**Docket Item
#12 A&B**

**DSP #2005-0018 (A)
SUP #2006-0054 (B)**

**Windows of Old
Town Condominium**

**Planning Commission
October 3, 2006**

North Royal Street Elevation

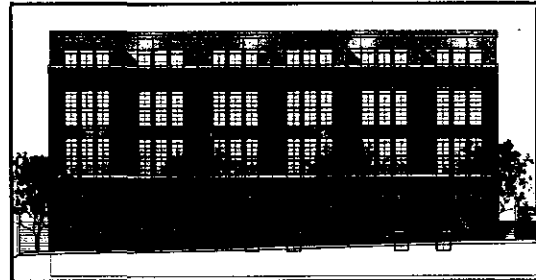
On North Royal Street, the buildings are located at the building line of the Hearthstone Mews homes, continuing the building edge and streetscape along that street. The style of the buildings are designed to be compatible with the townhouses of Hearthstone Mews with

North Fairfax Street Elevation

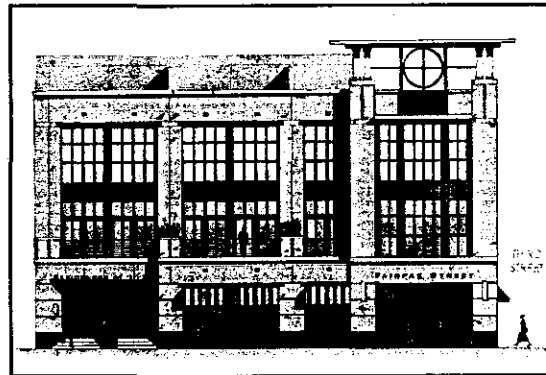
The building at the corner of Third and Fairfax Street has retail at the ground level and three units above. The entrance to the retail shops is conveniently located at the corner of the intersection. The building has a style that is compatible with the adjacent commercial uses across Third and North Fairfax Streets. The building has a tower element to signify the importance of the intersection. The first floor of the building has large store front windows and awnings for the retail use. Staff has added conditions that require refinements to these units and has also added conditions for the retail signage:
